CASE 863-V-16

SUPPLEMENTAL MEMORANDUM #4
September 14, 2017

COMPLETE DETENTION BASIN REGRADE
LOT 100
ROLLING HILLS ESTATES V SUBDIVISION
MAHOMET, CHAMPAIGN COUNTY, ILLINOIS

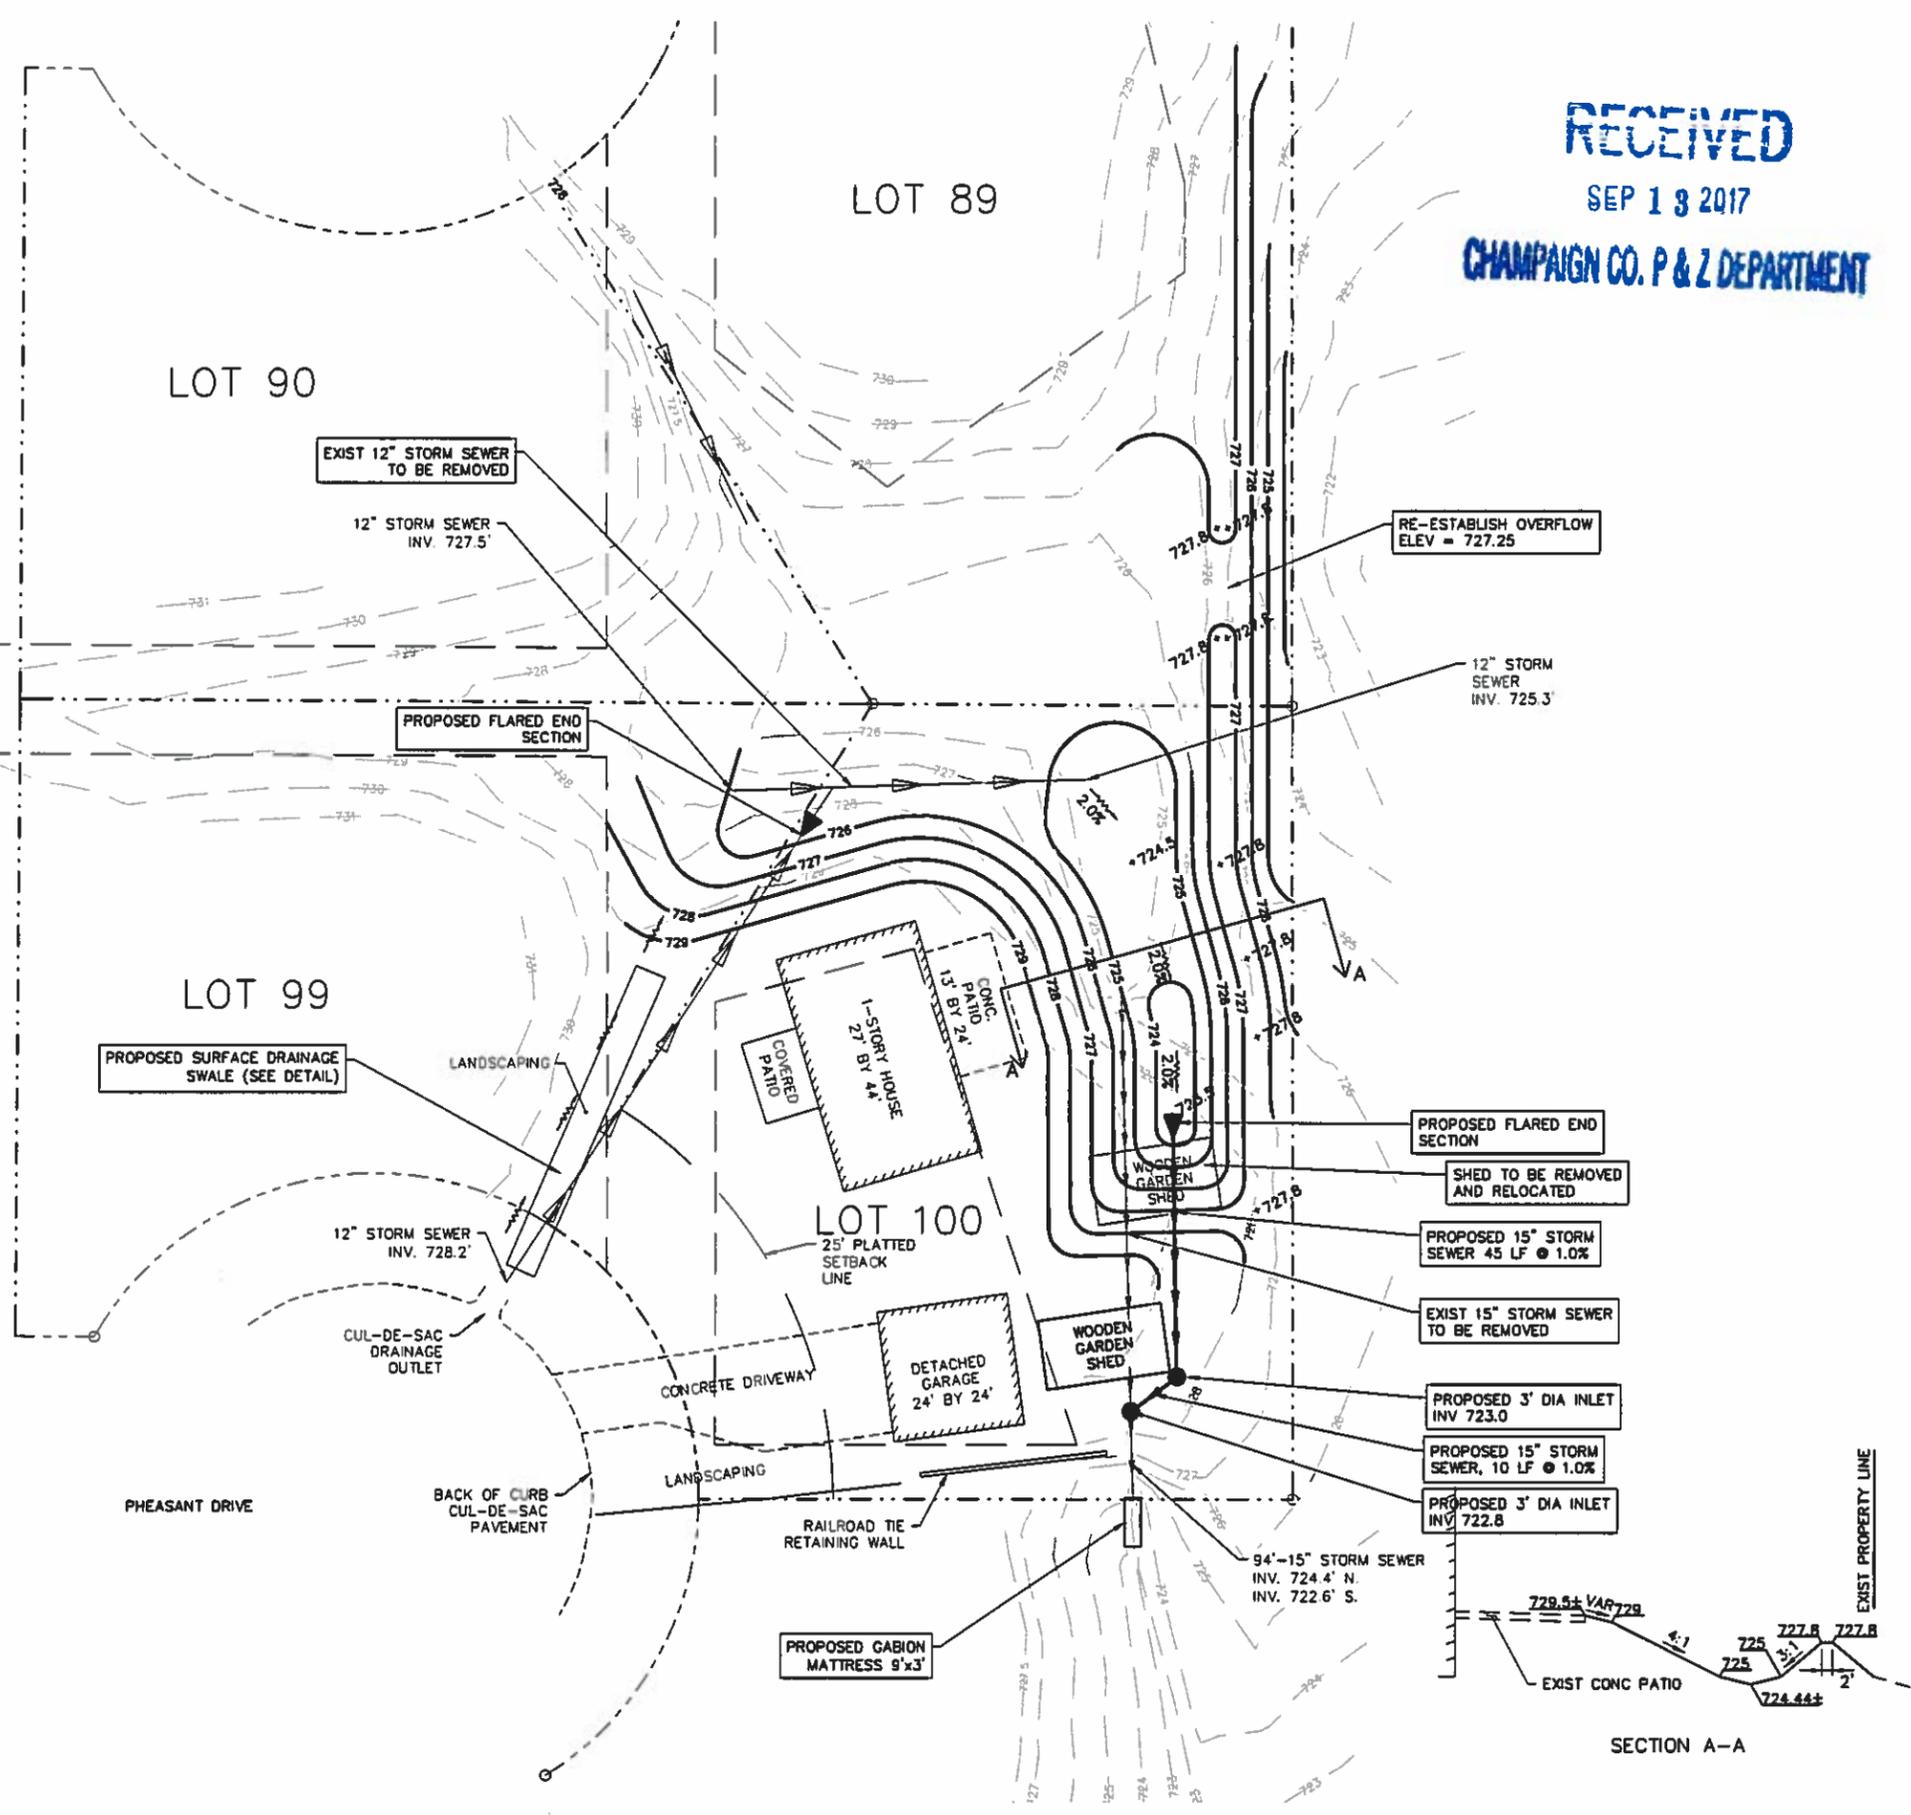
Mr. Wauthier's markup solution includes the following changes from the Phoenix Complete Detention Basin Regrade received September 1, 2017, as listed under Items 5.D. and 11.M.(3) of the Revised Summary of Evidence dated September 14, 2017:

- (3) Mr. Wauthier's markup solution includes the following changes from the Phoenix Complete Detention Basin Regrade received September 1, 2017:
 - a. Install one gabion mattress, 3 feet by 9 feet, installed just south of Lot 100.

- b. A one foot deep surface drainage swale where landscaping is indicated near west property line on Lot 99 and Lot 100.
 - c. Increase height of east berm to 727.8 feet instead of 727.5 feet on Lots 89 and 100.

- d. Add a flared end section to the storm sewer along the west property line and at the 15-inch storm sewer in detention basin.
 - e. A somewhat deeper basin with an outlet depth that has been lowered by six inches.

- f. Use a 2.0% slope instead of a 1.5% slope in the detention basin.
 - g. The basin outlet is 45 linear feet of 15-inch storm sewer at 1% slope rather than a 2.2% slope.

Mike Nickrent, Engineer with Phoenix Consulting Engineers, revised the Complete Detention Basin Regrade based on Mr. Wauthier's markup; P&Z Staff received this on September 13, 2017. P&Z Staff believe that the markup solution will have the effect of basic compliance with the *SWMEC Ordinance*.

- C. The Revised Complete Detention Basin Regrade received September 13, 2017, is the Official Site Plan for Case 863-V-16, which includes the following changes:**

- (1) Install one gabion mattress, 3 feet by 9 feet, installed just south of Lot 100.
- (2) A one foot deep surface drainage swale where landscaping is indicated near west property line on Lot 99 and Lot 100.
- (3) Increase height of east berm to 727.8 feet instead of 727.5 feet on Lots 89 and 100.
- (4) Add a flared end section to the storm sewer along the west property line and at the 15-inch storm sewer in detention basin.
- (5) A somewhat deeper basin with an outlet depth that has been lowered by six inches.
- (6) Use a 2.0% slope instead of a 1.5% slope in the detention basin.
- (7) The basin outlet is 45 linear feet of 15-inch storm sewer at 1% slope rather than a 2.2% slope.
